# Next board 2A capacitor mod

Everything you need to know to add a noise-filtering capacity to your 2A board.

The Spectrum Next noise before and after the capacitor mod

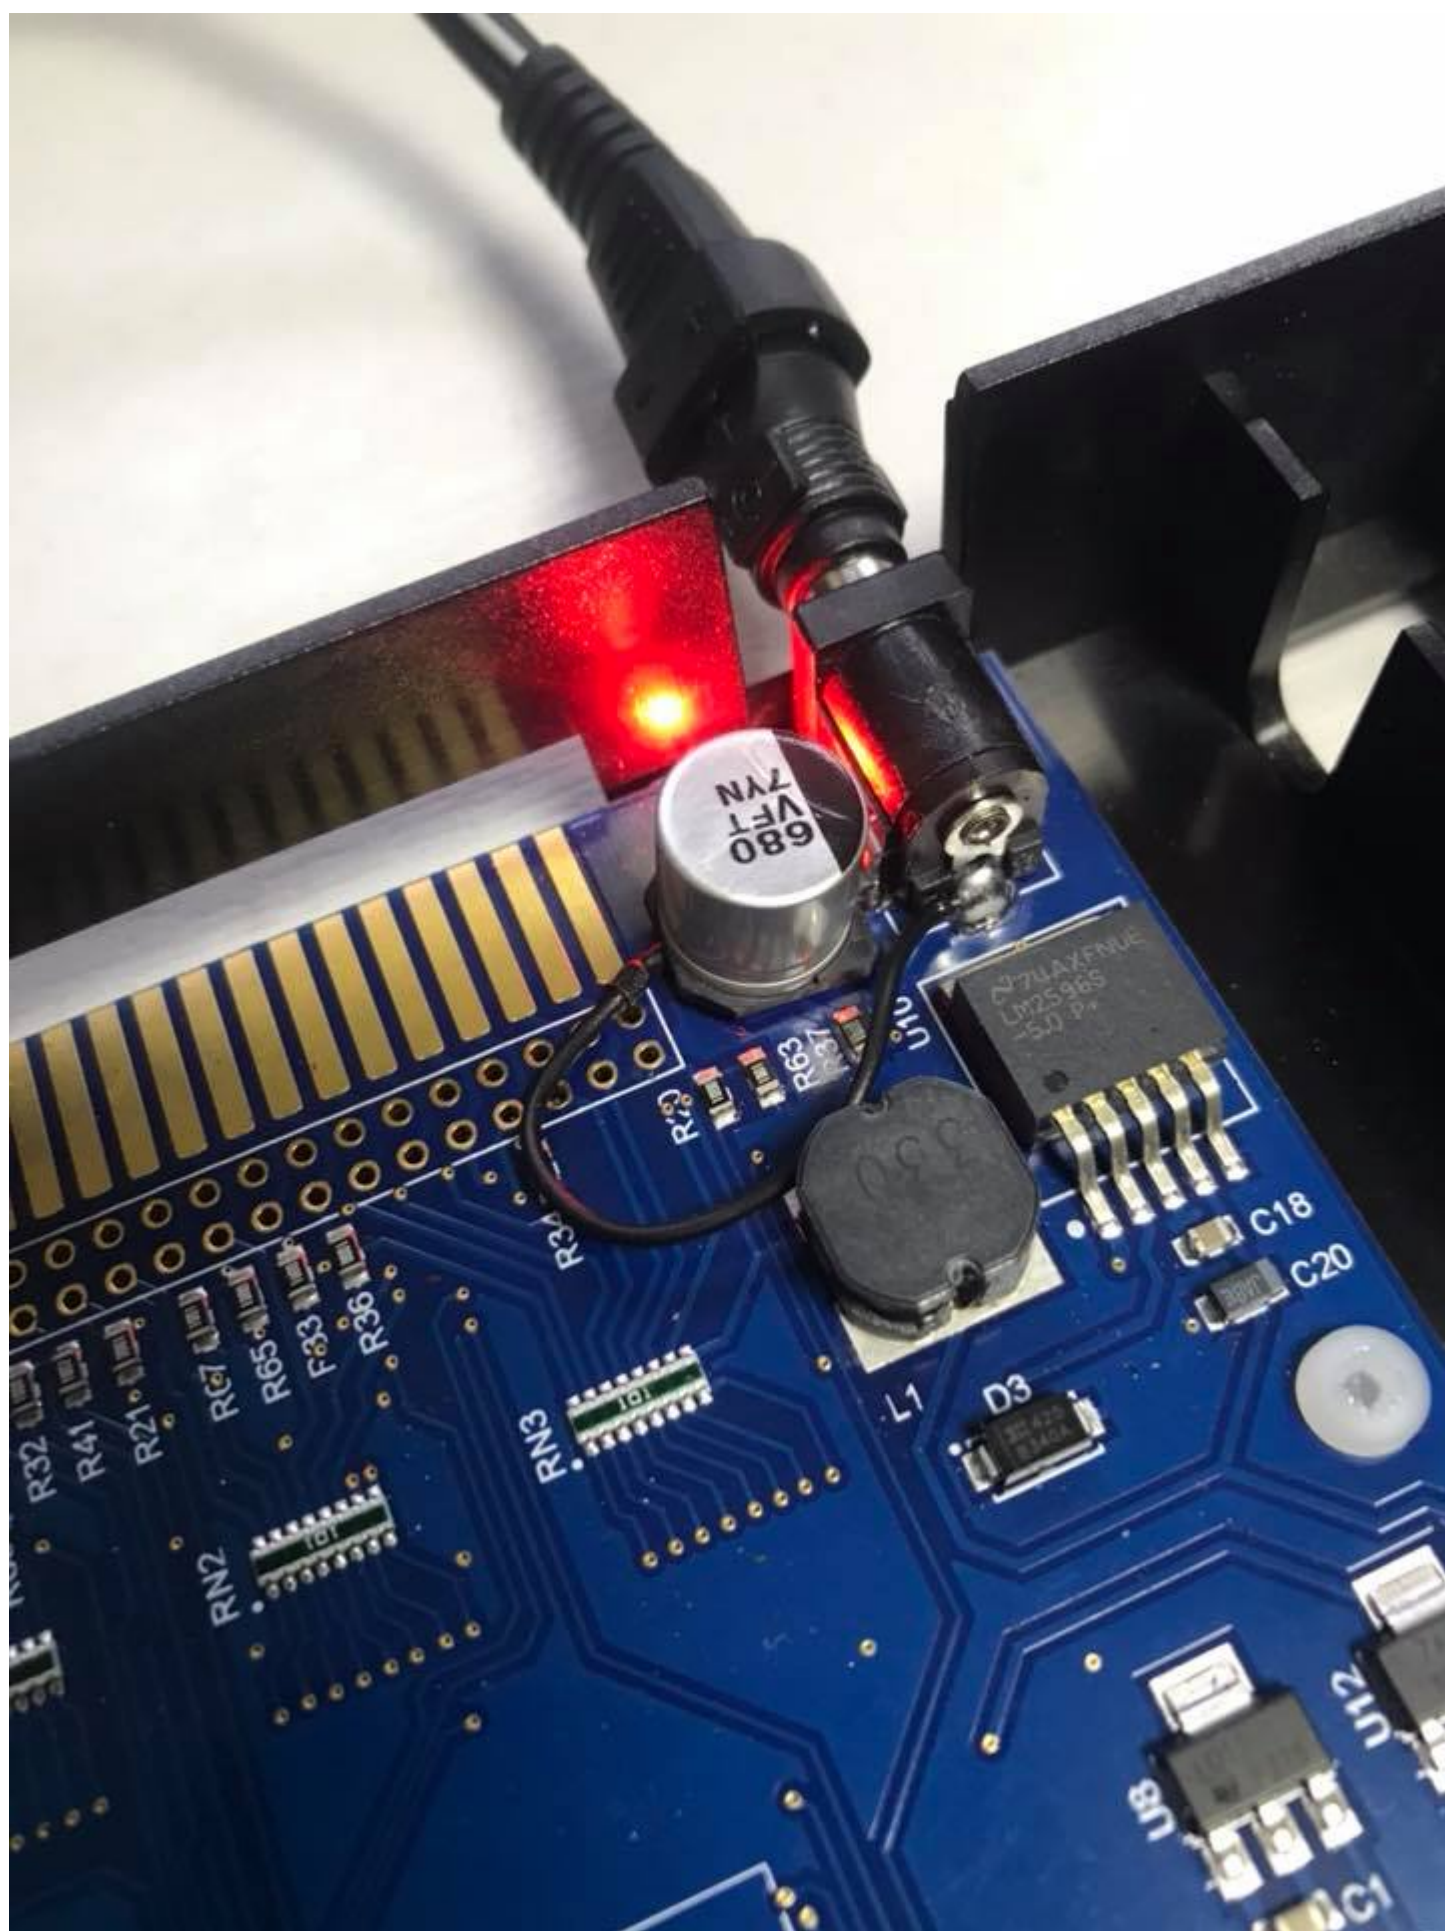
In a nutshell, the Next 2A allows noise from any PSU connected to it to filter through its components. This interference may vary from no side effect at all (most users) to video noise to HDMI incompatibilities. In order to fix the problem, a capacitor must be soldered to the 2A board voltage input, thus eliminating interferences.

There are a wide range of capacitors that can be used, as long as they have polarity (+/-). A range of 100µF to 680µF, around 25V to 35V is ideal. The final Spectrum Next (version 2B) features this by default, and uses a 470µF 25V capacitor. Here are some links to purchase the capacitor:

The capacitor soldered to the 9V connector. The black notch indicates (-) polarity, thus soldered to the side of the connector, while the (+) leg of the capacitor goes in the middle of the connector.  
Photo by Jon Gratton (FB Next group).

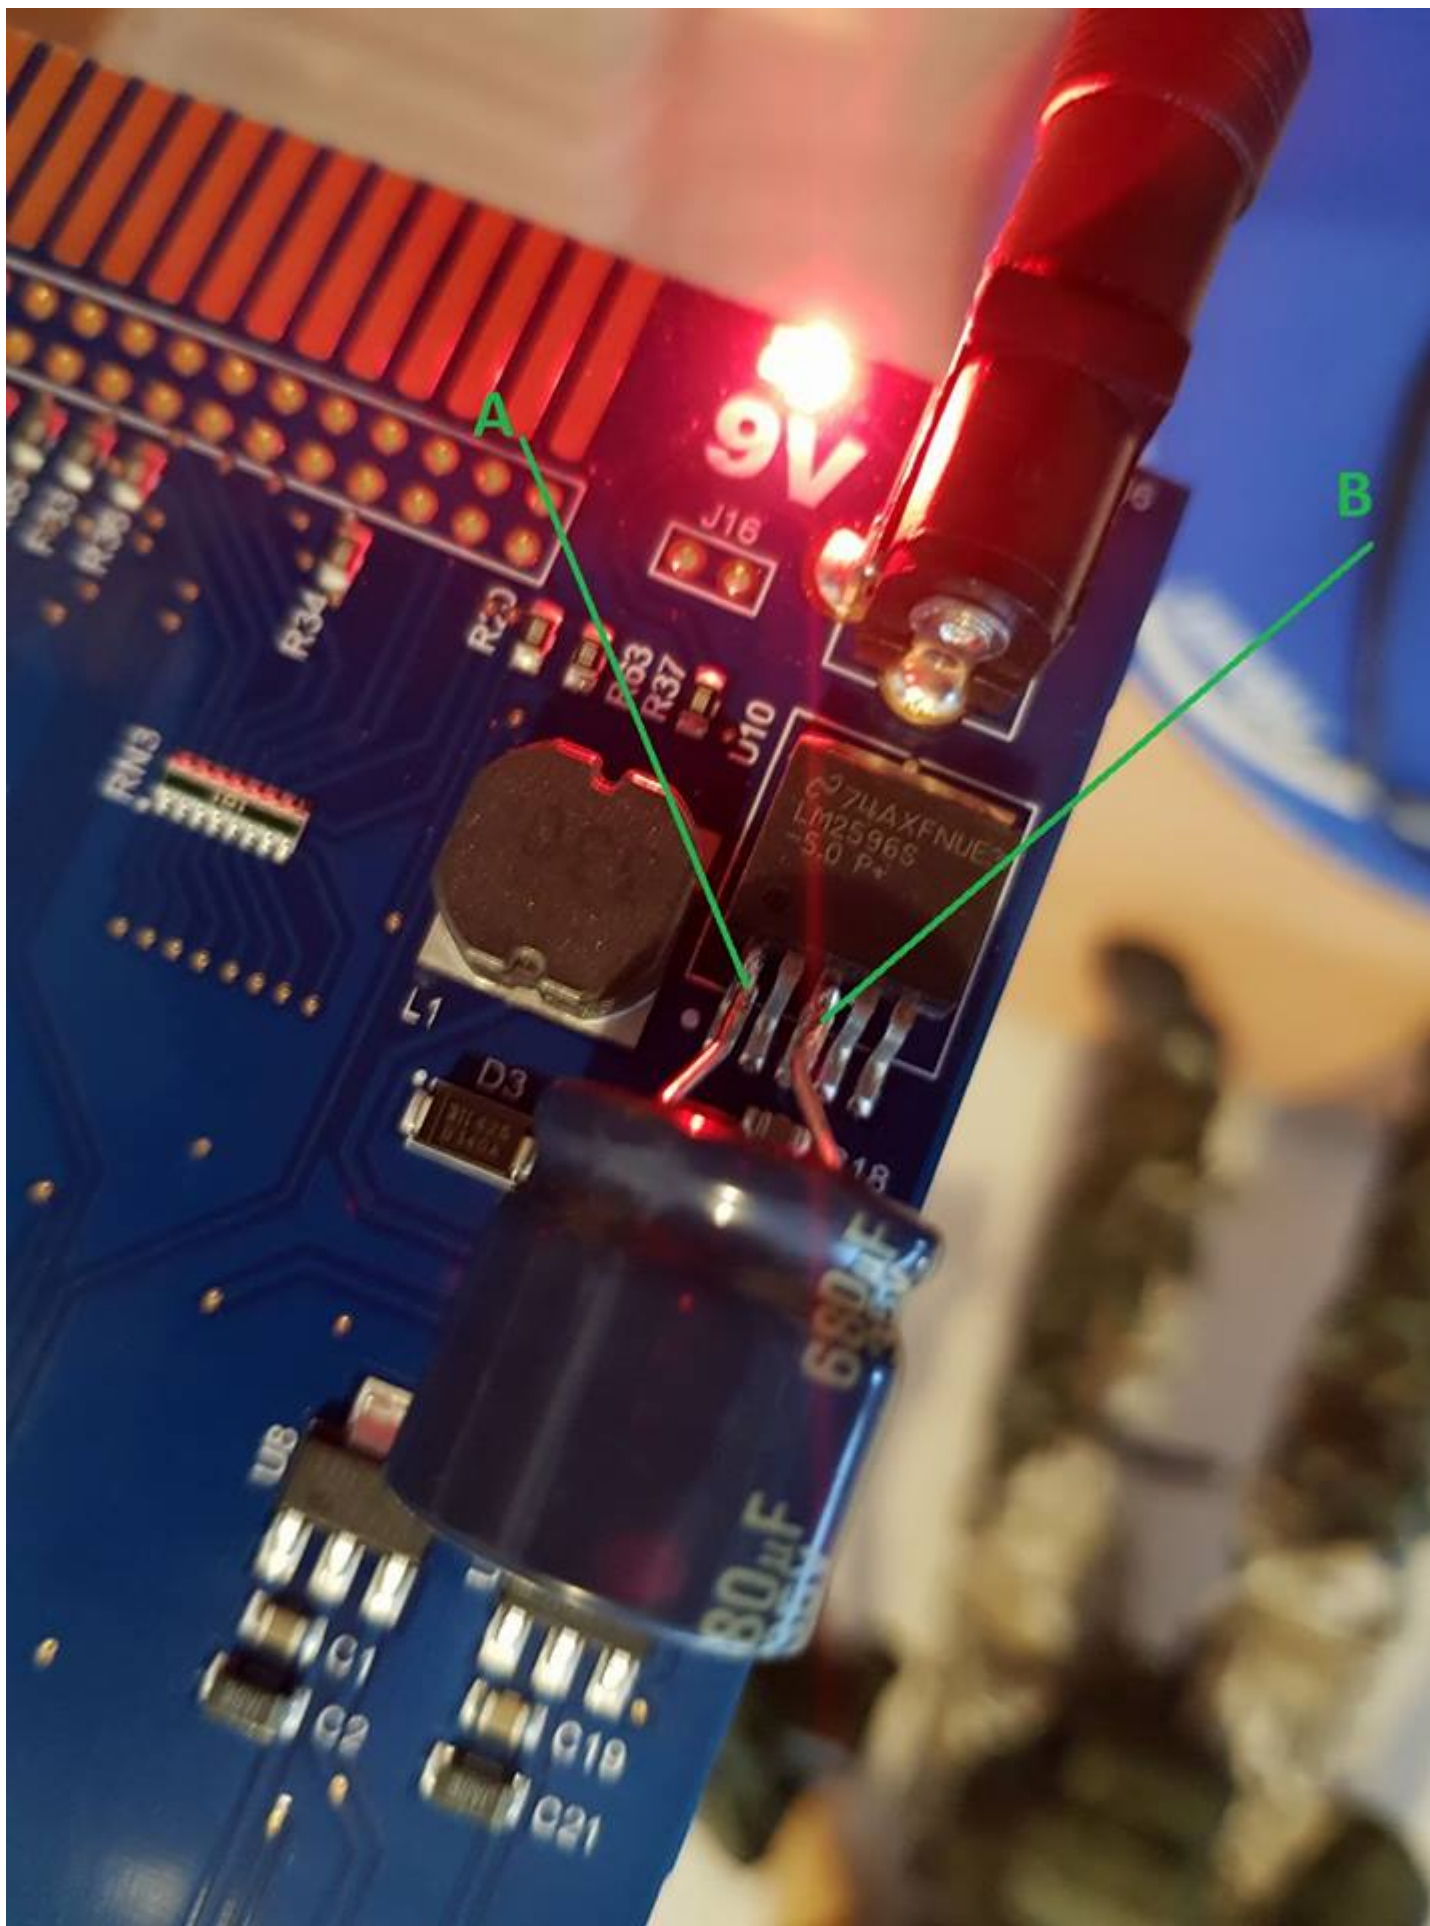
There are two places where the capacitor can be soldered: directly to the 9V connector on the top right corner of the board (labelled 9V) or on the voltage regulator right below the connector (labelled U10).

The capacitor on the voltage regulator U10. A is (+) and B is (-). Photo by Adrian Cummings and annotations by Deon du Plessis, Next FB group.

Whatever the place you chose to solder the capacitor, it's **VERY IMPORTANT** to observe the polarity of the capacitor: it's negative (-) pole needs soldering to the negative of the 9V connector (on its side) or the middle leg of the voltage regulator U10 (B in the picture above). The positive (+) pole is soldered to the back/middle of the 9V connector or the left leg of the voltage regulator U10 (A on the picture above).
